DESIGN REVIEW  
RECOMMENDATION PROPOSAL

3400 Wallingford Ave N - 3014232  
3326 Wallingford Ave N - 3014233

Application Date:  
August 30, 2013

### C-3: Human Scale

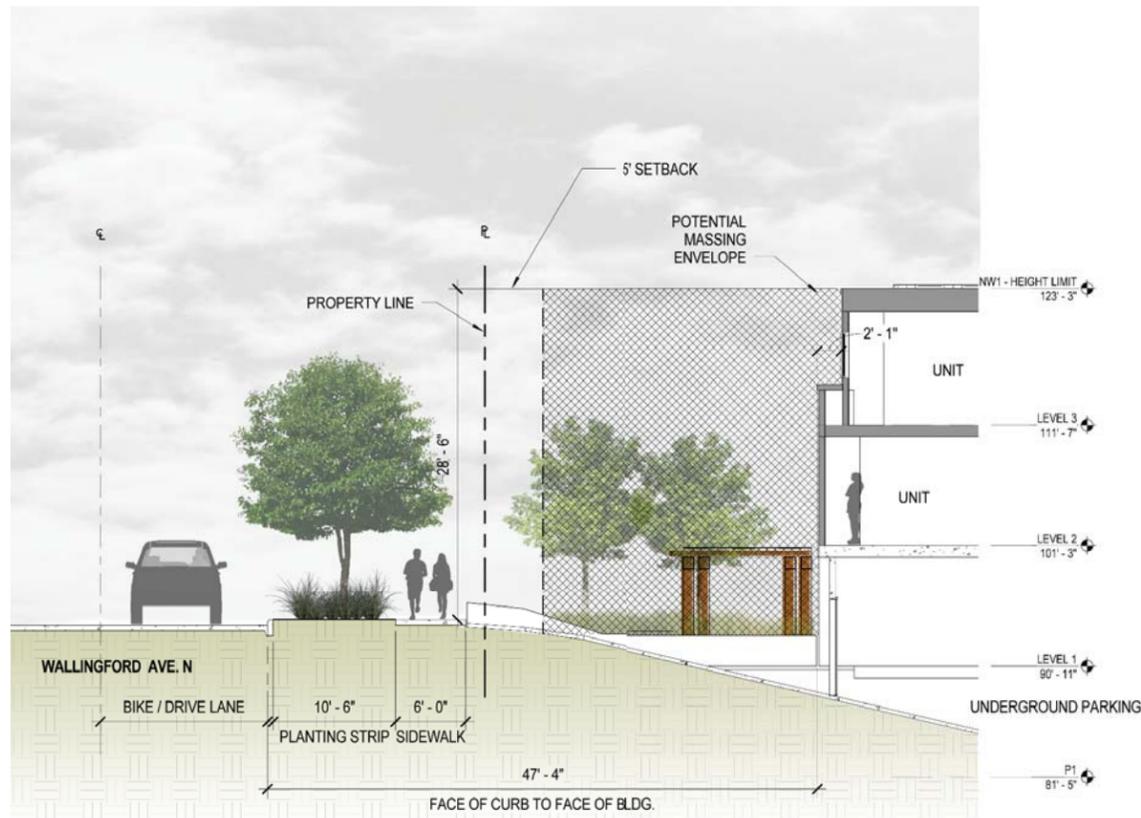
*Reduce the scale of the two buildings on the north site by creating three separate structures or separate the structures in the LR2 zone from the larger buildings. See B-1 guidance.*

The plans have been revised to achieve the goal of reducing the perceived scale of the two buildings on the north site using increased setbacks, changes in building height, upper level setbacks and vertical and horizontal modulation.

**B1: Height, Bulk and Scale Compatibility**

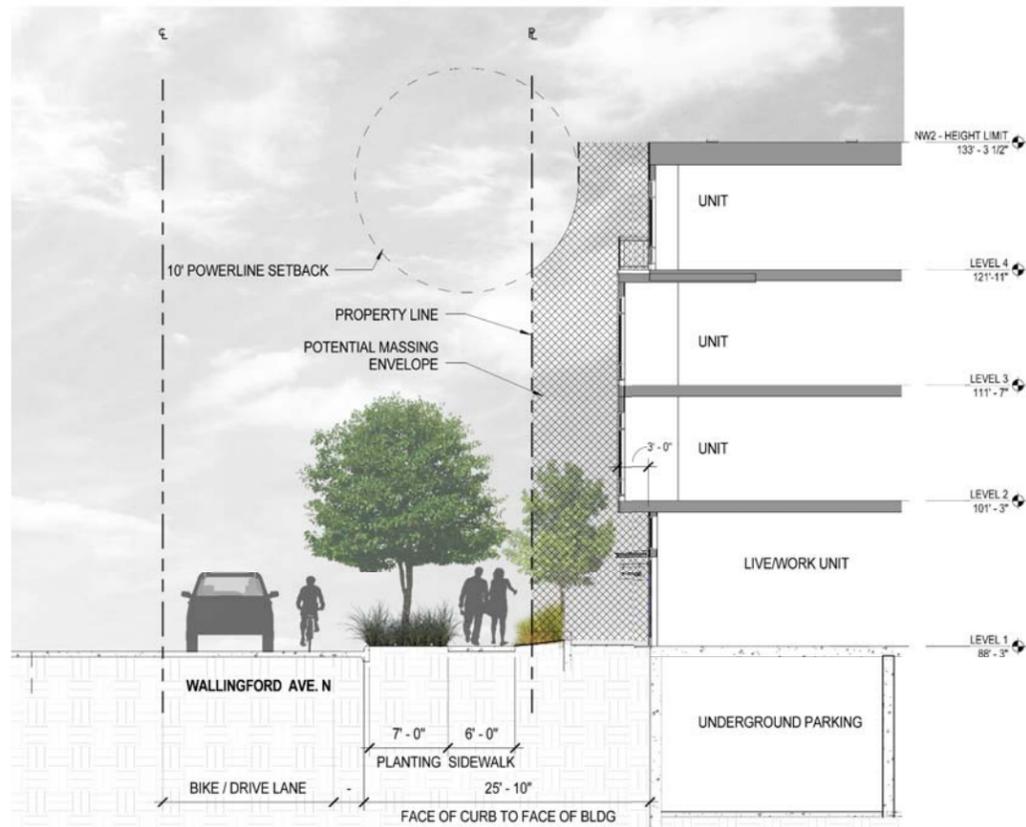
**EDG COMMENT:**  
Five floors face Burke with much of the upper levels projecting toward the street. Both the structures' lengths and the projecting upper levels represent architectural ideas or patterns counter to the Wallingford specific guidelines .

**RESPONSE:**  
While correct that upper levels project over mid-levels, significant upper level setbacks are provided, achieving the goals of the Wallingford specific guidelines. Lower levels are setback for increased open space, landscaping, and weather protection as described in A-1 and A-10 above .  
Similar to the Biscayne, the building along Wallingford and Burke is provided with upper level setbacks as revised in the current plans. Additional setbacks are provided at mid levels and lower levels significantly in excess of code requirements to provide additional openspace and public view opportunities along Wallingford and 34th Street, which are public view corridors. These setbacks significantly increase the open space and view opportunities from the existing conditions which are immediately adjacent to the property lines.

**B1: Height, Bulk and Scale Compatibility**

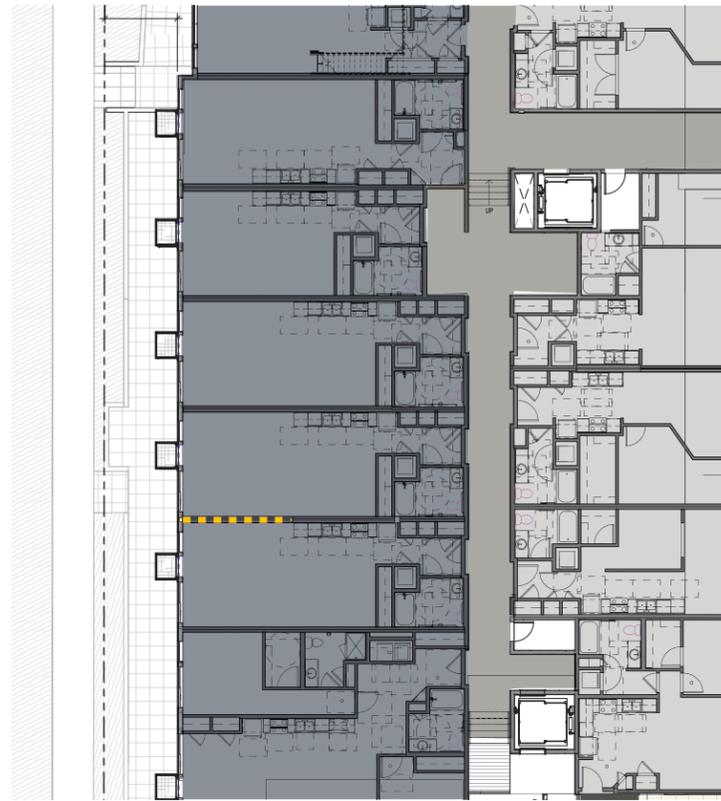
**EDG COMMENT:**  
Five floors face Burke with much of the upper levels projecting toward the street. Both the structures' lengths and the projecting upper levels represent architectural ideas or patterns counter to the Wallingford specific guidelines .

**RESPONSE:**  
While correct that upper levels project over mid-levels, significant upper level setbacks are provided, achieving the goals of the Wallingford specific guidelines. Lower levels are setback for increased open space, landscaping, and weather protection as described in A-1 and A-10 above .  
Similar to the Biscayne, the building along Wallingford and Burke is provided with upper level setbacks as revised in the current plans. Additional setbacks are provided at mid levels and lower levels significantly in excess of code requirements to provide additional openspace and public view opportunities along Wallingford and 34th Street, which are public view corridors. These setbacks significantly increase the open space and view opportunities from the existing conditions which are immediately adjacent to the property lines.

**A-10: Corner Lots**

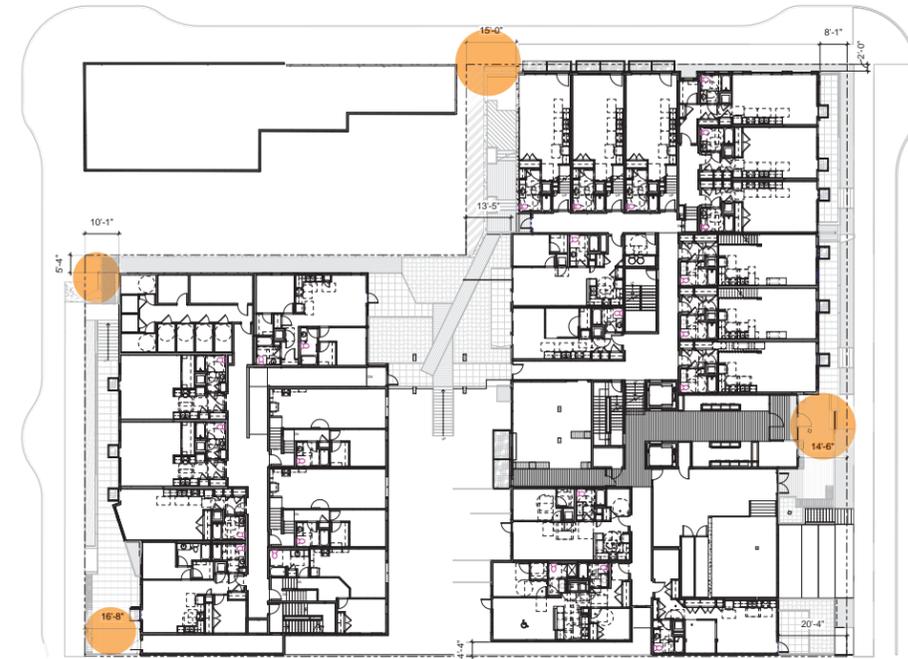
The two sites have three highly visible corners. Fully integrate into the design the specific neighborhood guidance for corner lots in Wallingford. . . Buildings anchor corners in a variety of ways. Plazas, shaped by the structure's massing, provide a strong definition to corners.

Open spaces are also provided at Burke Avenue North on each side of N 34th street. On the north side of 34th a plaza nicknamed "The Burke Landing" provides seating and greenery adjacent to the lobby and leasing entry. This area provides a visual and material connection across 34th with the boardwalk material that connects to "The Docks" on Wallingford. On the south side of 34th, the live work units provide terraces out to the sidewalk on 34th and around the corner onto Burke to allow retail uses to spill out from the storefronts to provide pedestrian interaction with tables, chairs, and / or wares.

### A-7: Residential Open Space

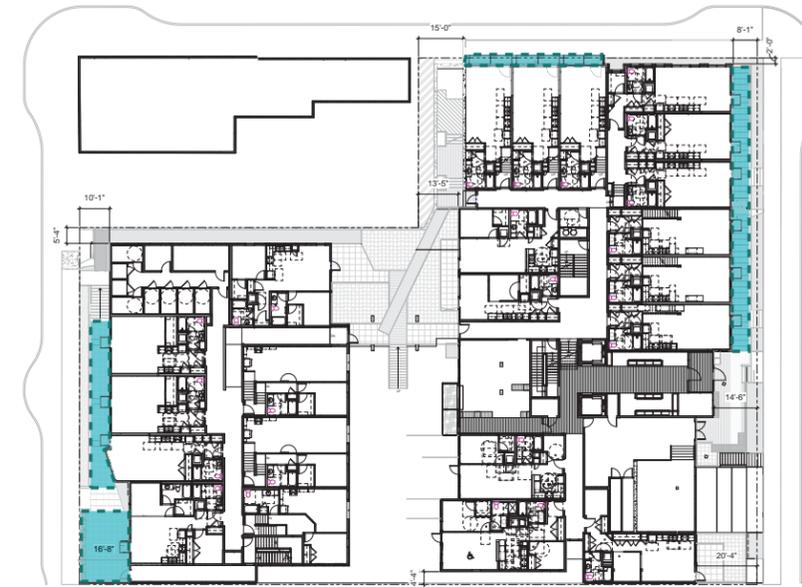
The varying levels of the open spaces suggested in the landscape diagrams should allow for accessibility. On the north site, these sequences of spaces appear promising.

**C-3: Human Scale**

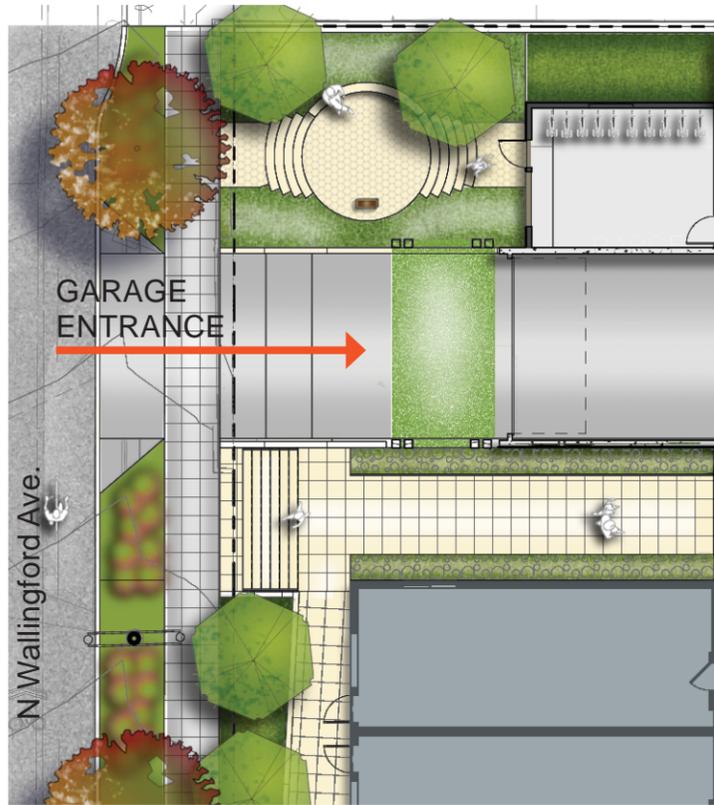
*EDG COMMENTS:*  
The guidance for C-1 and C-4 discusses the importance of reducing the project's scale. The skybridges should be eliminated due to the deleterious impact on the quality of the open space and the unnecessary addition to the building mass.

**RESPONSE:**  
The skybridge on the north site has been revised to delete the top two stories to reduce the extent of shadow it would cast and to reduce its scale and mass, significantly reducing its prominence in the courtyard.  
Both skybridges have been revised to include additional glazing to improve transparency and openness, further reducing mass and scale.  
The now light, airy, and open skybridges provide the benefit of breaking up the plazas into defined areas of use. The skybridges also serve to connect buildings together to minimize the need for additional stairs, which would necessitate additional rooftop penthouses, and to improve the sense of community within the buildings.

**RESPONSE:**  
The skybridges have been revised as discussed above to address the design goals of improving the experience of the internal open space while maintaining an important connection that encourages and facilitates interaction between residents.

**North Garage Entrance Plan**

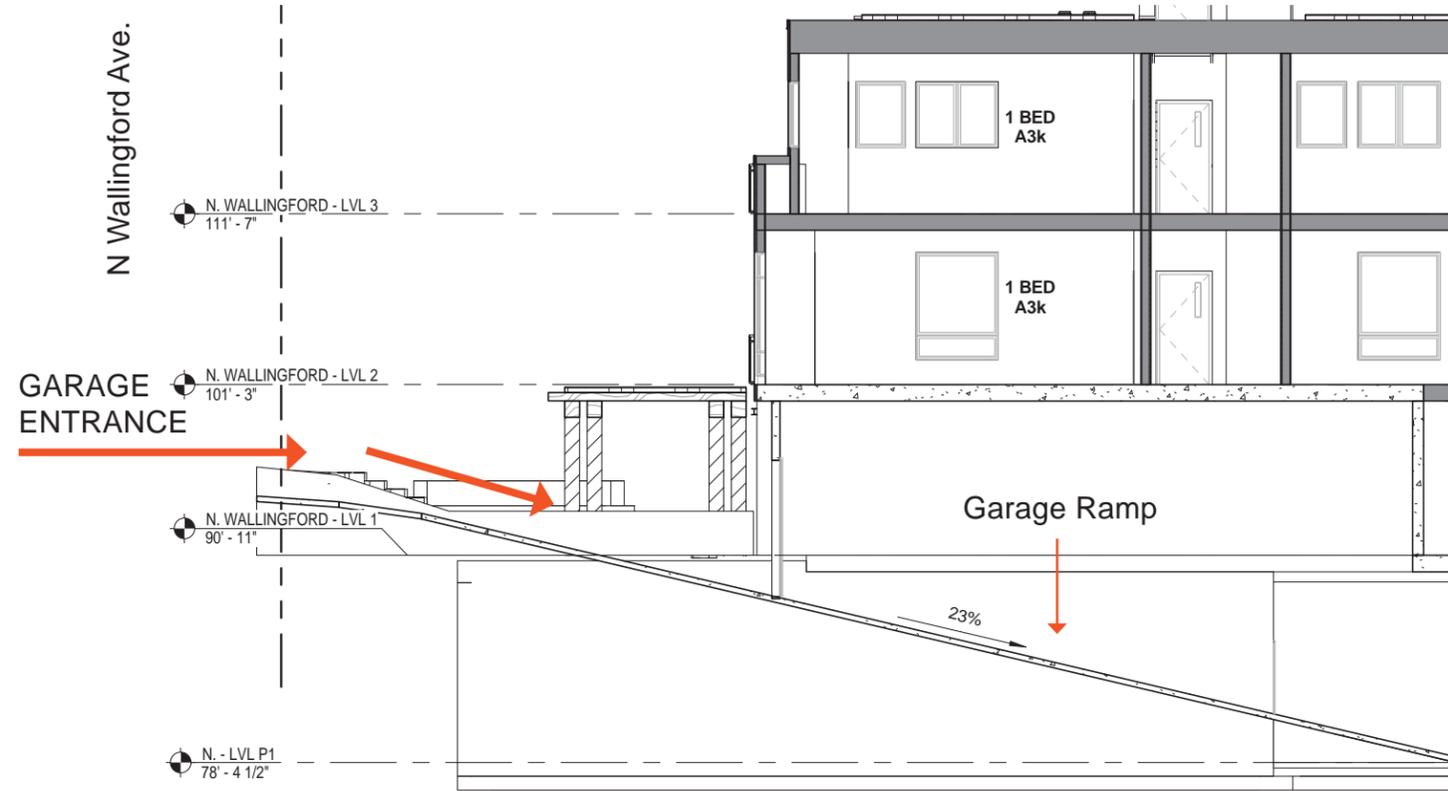
**EDG COMMENTS:**  
 Locating garage access for the north site on Burke Ave is problematic for many of the reasons stated in the public comment section. Further exploration of alternative locations needs to occur as well as a study of techniques for directing traffic away from the adjacent lowrise and single family zones.

**RESPONSE:**  
 The parking access for the north block has been relocated to Wallingford Avenue, eliminating this issue .

South Garage Entrance Plan

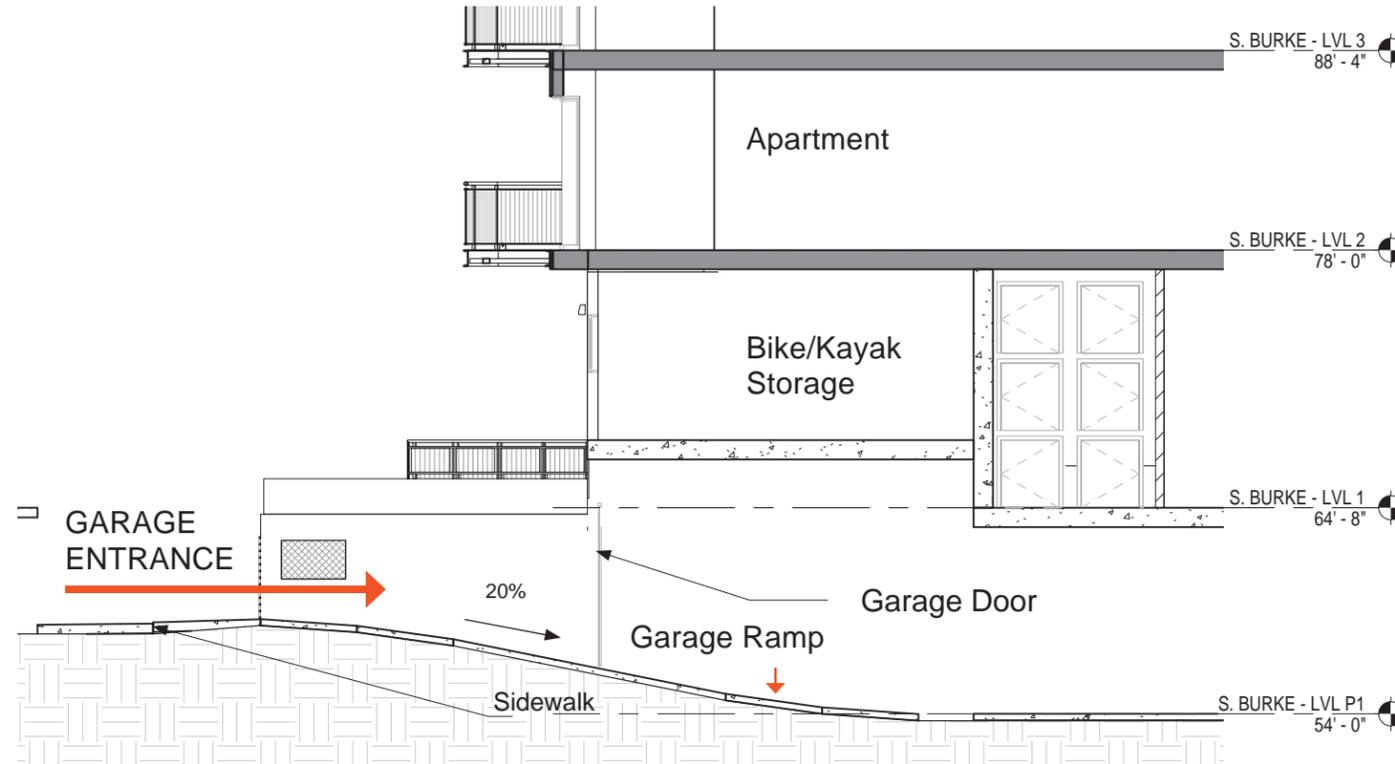
Locating garage access for the north site on Burke Ave is problematic for many of the reasons stated in the public comment section. Further exploration of alternative locations needs to occur as well as a study of techniques for directing traffic away from the adjacent lowrise and single family zones.

**C-1: Architectural Context**

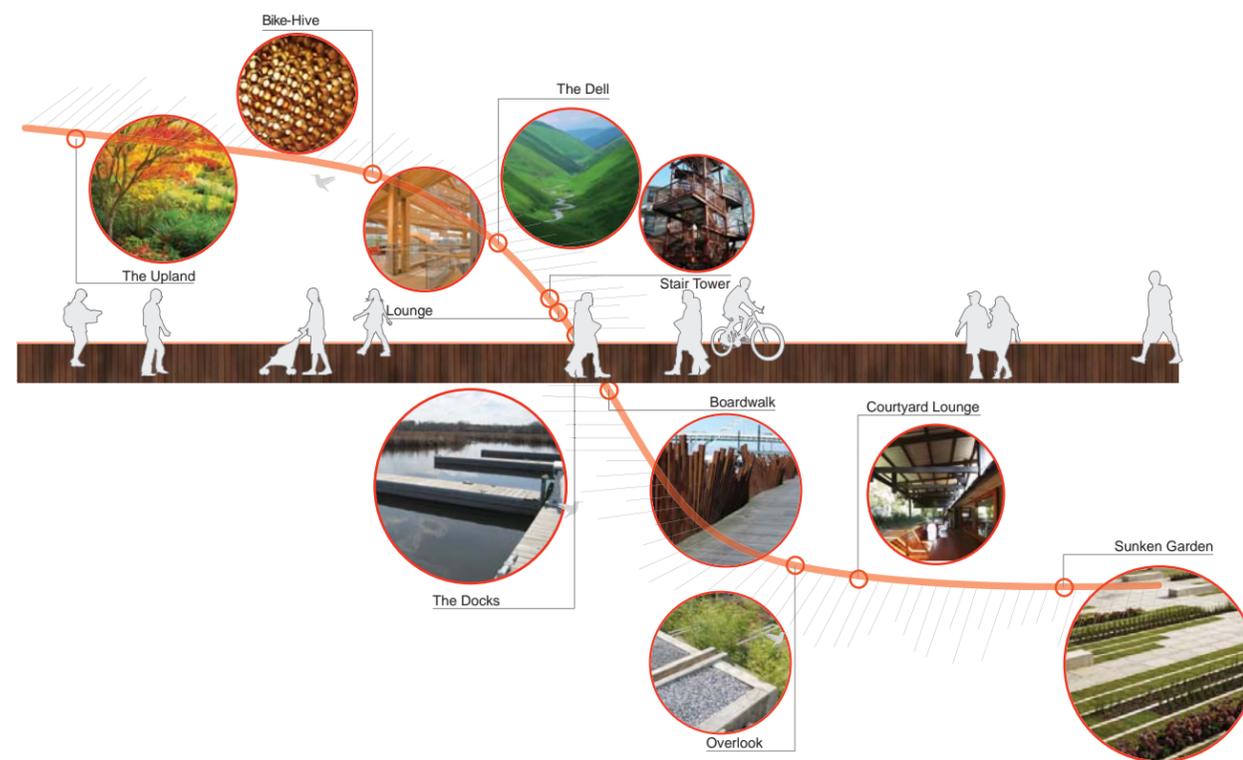
The neighborhood specific guidelines encourage a traditional approach to design. The proposal ought to honor the principles outlined but, as stated above, the imagery does not need to have a historicist character.

**N Wallingford Ave. Elevation**

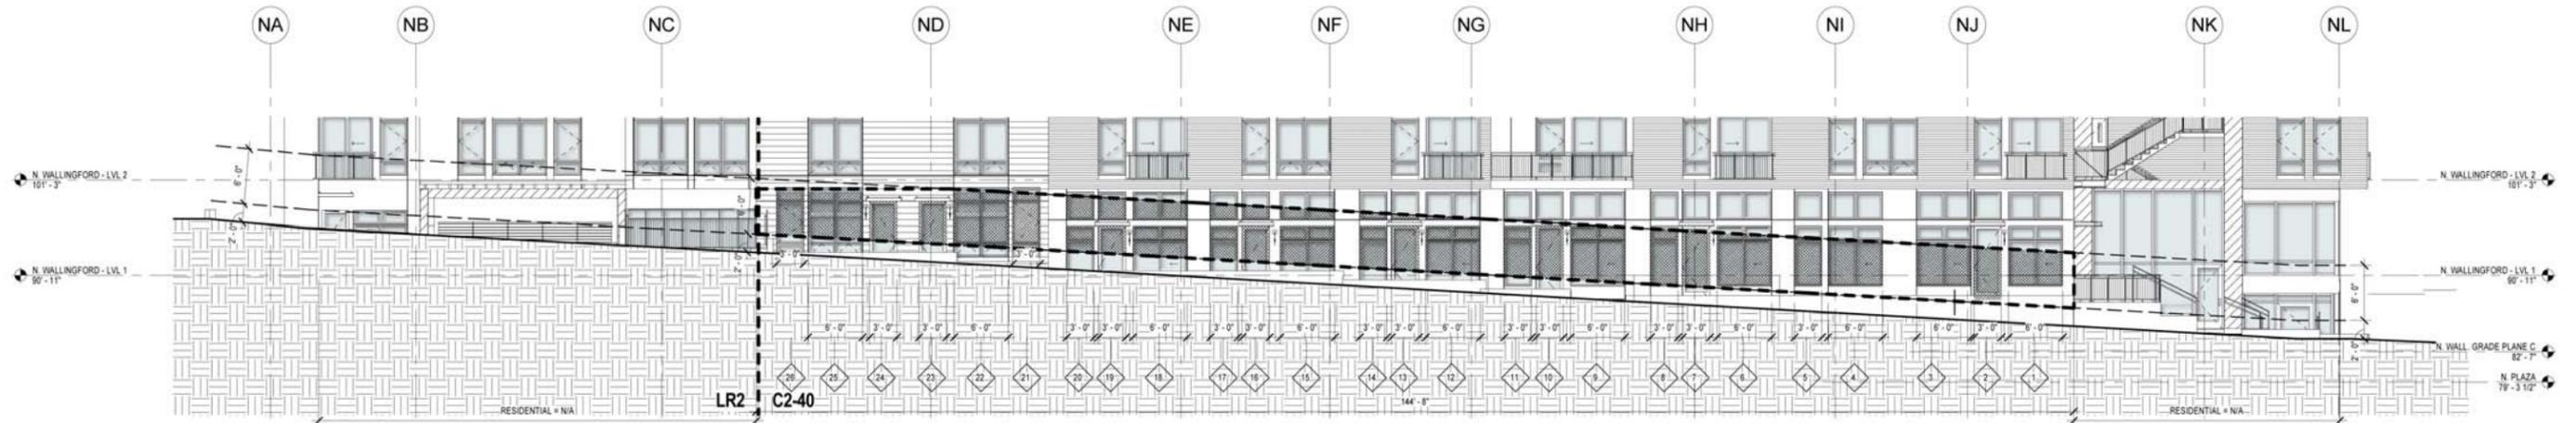
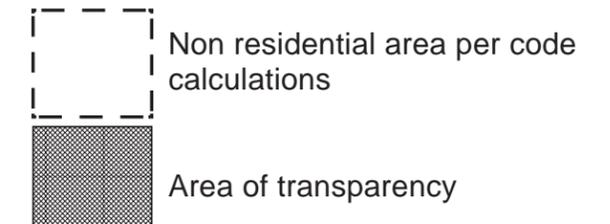
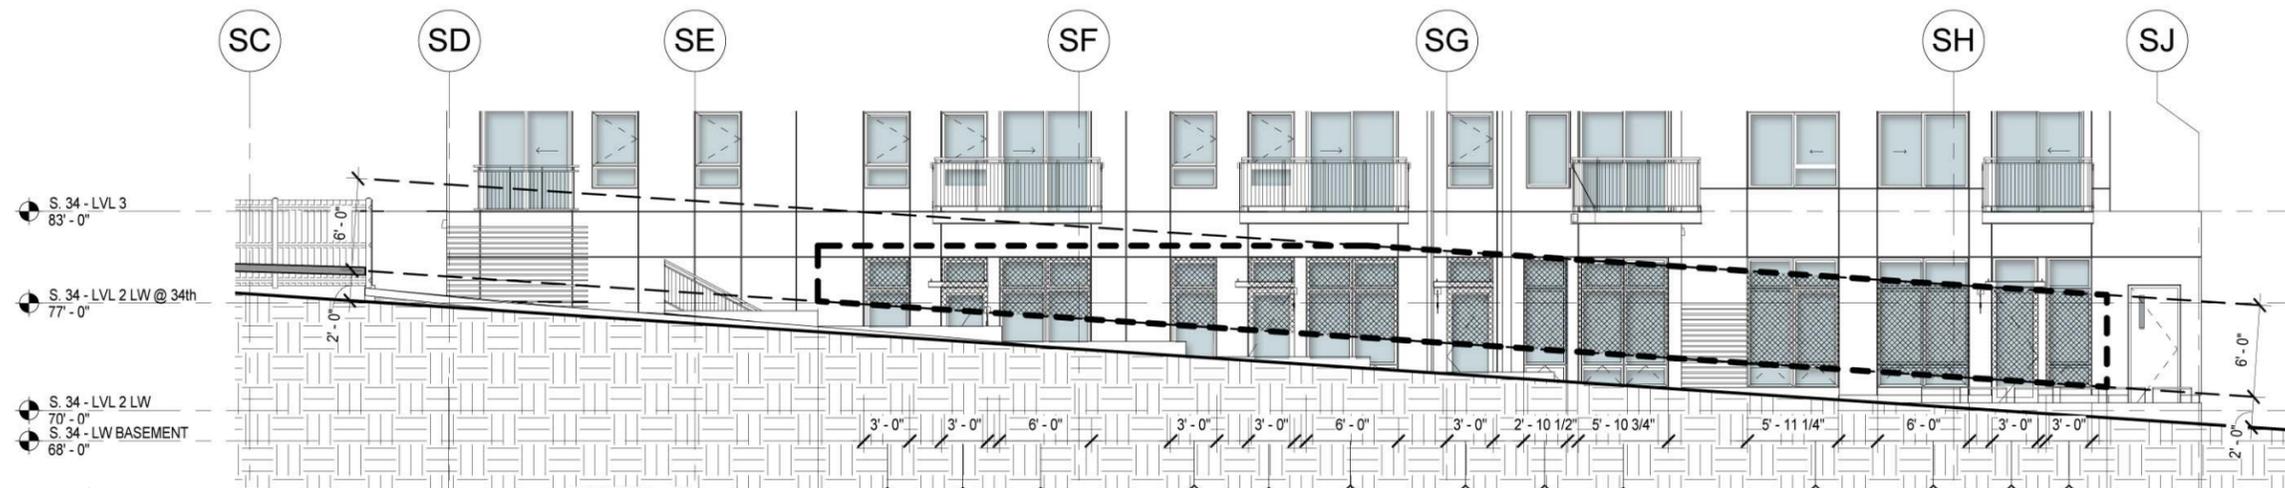
The live/work units should be treated similar to commercial storefronts .

Blank walls are minimized and corresponding transparency maximized along the length of the commercial façades. Elevations have been revised to add glazing and the departure request for blank wall has been rescinded.

See discussion of blank walls in D-2 above  
The live-work units will have a significant amount of glazing to achieve the transparency goal. Elevations have been revised to add glazing and the departure request for transparency has been rescinded.
